**APPLICATION FOR PERMISSION
UNDER SECTION 16 OF
THE TOWN PLANNING ORDINANCE
(CAP.131)**

For Official Use Only 請勿填寫此欄	Application No. 申請編號	A/7L-LFS/417
	Date Received 收到日期	25 NOV 2021

Applied use/ development 申請用途/發展	Proposed Temporary Public Vehicle Park for Private Cars for a Period of 3 Years and Filling and Excavation of Land

Proposed Temporary Public Vehicle Park for Private Cars for a Period of 3 Years and Filling and Excavation of Land at

Figure 4

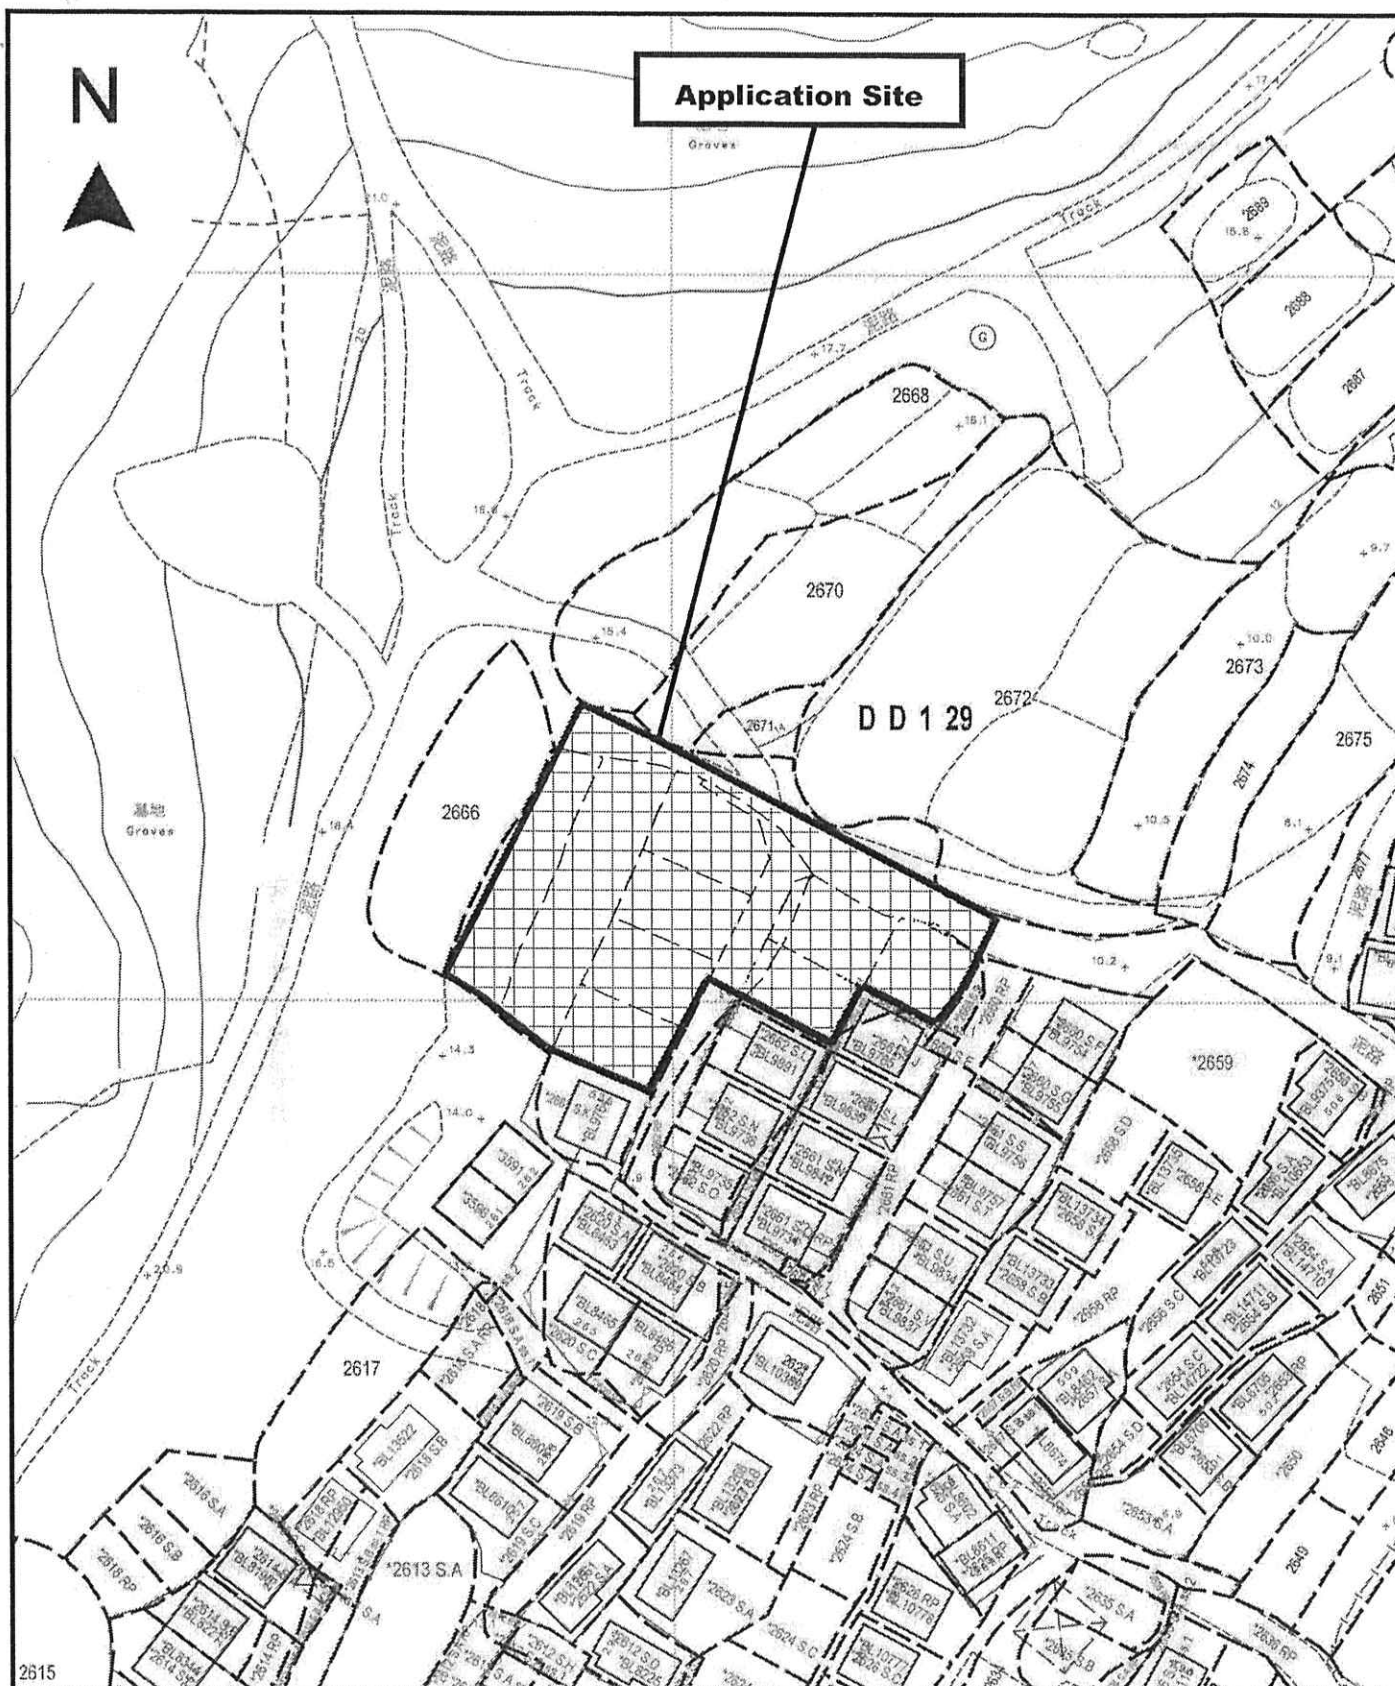
- (i) to note the comments of the Chief Engineer/Mainland North, Drainage Services Department (CE/MN, DSD) on the submitted drainage proposal that (1) the invert levels of the proposed catchpits should be shown on the drainage plan for his consideration; (2) details for the connection to the existing drainage facilities should be provided; (3) standard details should be provided to indicate the sectional details of the proposed U-channel and the catchpit; (4) sand trap or provision alike should be provided before the collected runoff is discharged to the public drainage facilities; (5) the development should neither obstruct overland flow nor adversely affect existing natural streams, village drains, ditches and the adjacent areas, etc.; and (6) the applicant should consult DLO/YL of LandsD and seek consent from the relevant owners for any drainage works to be carried out outside his lot boundary before commencement of the drainage works;

Figure 1. Aerial photo (left) showing the site and its surroundings (approximate marked by the red circle); application site as shown in the gist (right).

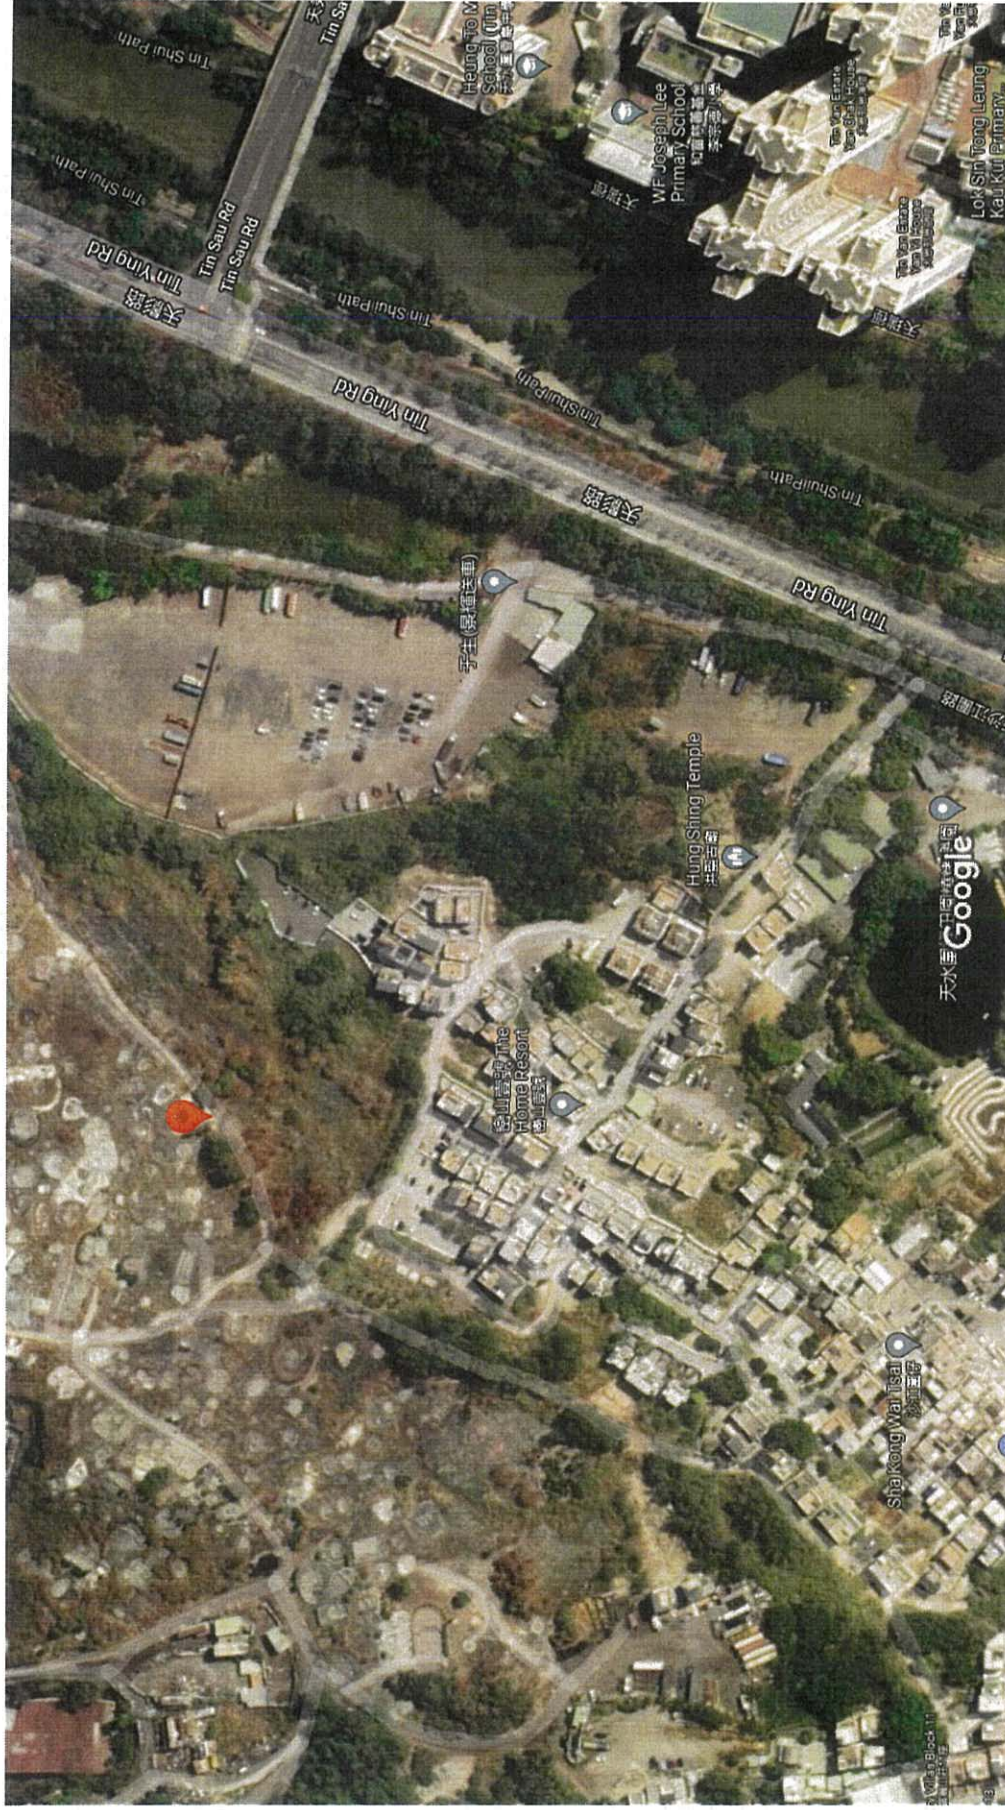
1. We refer to the captioned.
2. We urge the Board to look at an aerial photo taken in July 2021 which shows the application site and its surroundings (**Figure 1**).
3. We urge the Board to investigate with relevant parties/ authorities as to whether the site is now, partially or wholly, paved with concrete and whether it is now, partially or wholly, used as a car park already. We also urge the Board to investigate with relevant authorities as to whether any previous planning permission has been granted for car park use within the application site.
4. We also urge the Central Enforcement and Prosecution Section of the Planning Department to investigate this site and to see whether there are unauthorised activities/ uses.
5. We urge the Board to critically think whether the planning application system is an apply

6. Please note that the site is largely within Green Belt (GB) zone and its planning intention is *'primarily for defining the limits of urban and sub-urban development areas by natural features and to contain urban sprawl as well as to provide passive recreational outlets. **There is a general presumption against development within this zone**'²*. We also urge the Board to look at the size of the Village Type Development (V) zone in the locality and to consult relevant authorities as to whether there would still be vacant space in this V zone.

7. We urge the Board to reject this application as the proposed use is not in line with the planning intention of the GB zone and we urge the Central Enforcement and Prosecution Section to investigate the site. We also urge the Board to consider the potential cumulative impact of approving this application on the GB zone of concern as the approval would set a precedent for similar applications in the GB zone in this area.
